ADDENDUM #1

WMB ARCHITECTS	CMC NORMANDY VILLAGE MEDICAL CLINIC TI STRUCTURAL SUPPLEMENTAL DETAILS 7912 N WEST LANE STOCKTON, CA 95210	ORIGINAL SHEET REFERENCE S2 16-129 12/07/17 SHEET AR5.1
--	---	--

7 DETAIL
1-1/2" = 1'-0"

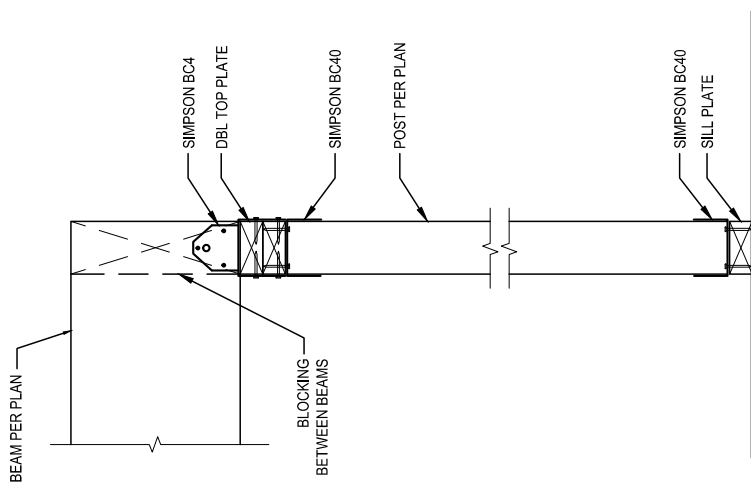
12. Please provide details for the connection for the post to concrete and post to beam connections for the operable partition support framing and cabinet support framing mentioned on page S2. **ANSWER – See attached document AR5.1 showing typical details for post / beam connections.**

FINISH PLAN
SCALE: 3/32" = 1'-0"

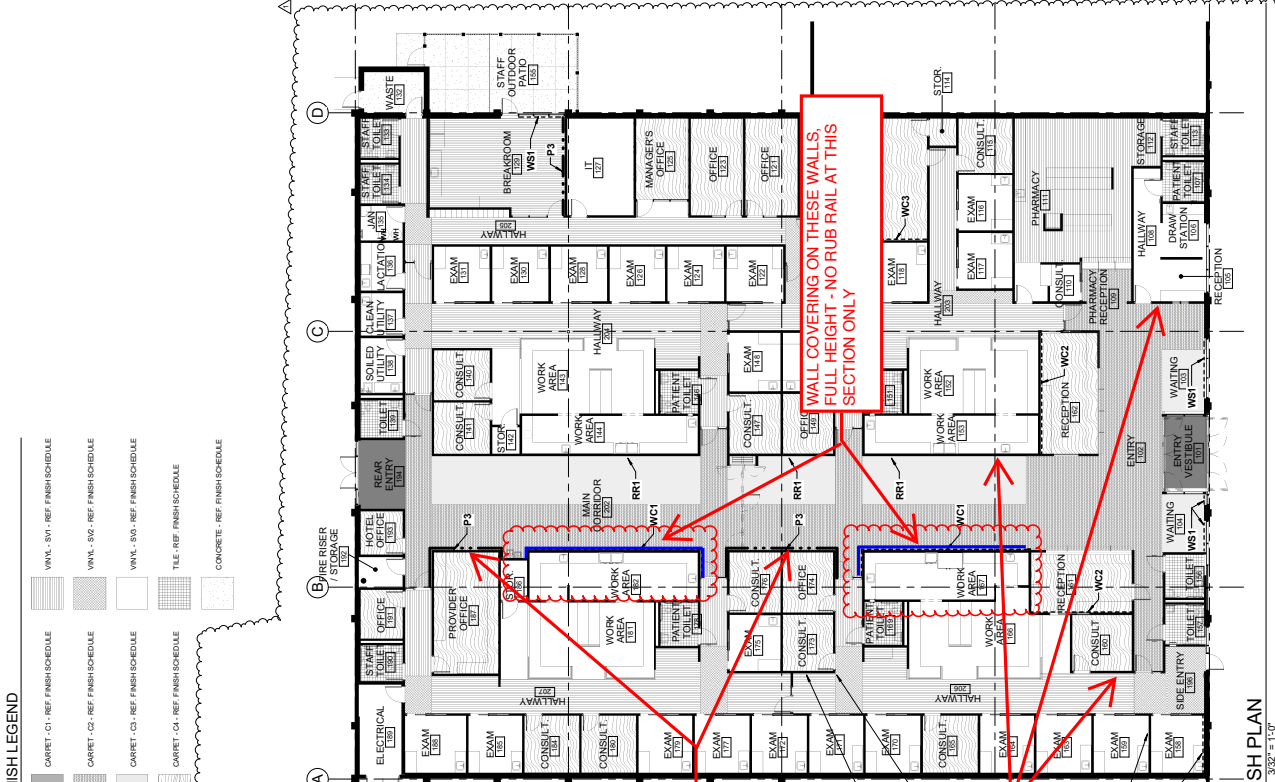
12. Please clarify answer 1 on addendum #3 regarding the location of wallcovering and rub strips. It is unclear where these go as the hallway is a somewhat undefined area. **ANSWER – See attached Sheet A10.1 highlighting where wallcovering is to be located, and where rub strips are to be located. Also, to clarify, corner guards to be 48" high, not full height.**

23. The finish schedule and finish legend/plan do not match. In this case which one is correct? If the schedule is correct which carpet is C5? C5 is not shown on the legend. **ANSWER – Finish legend/plan is correct. See attached document AR5.2 (updated A10.1 with corrections).**
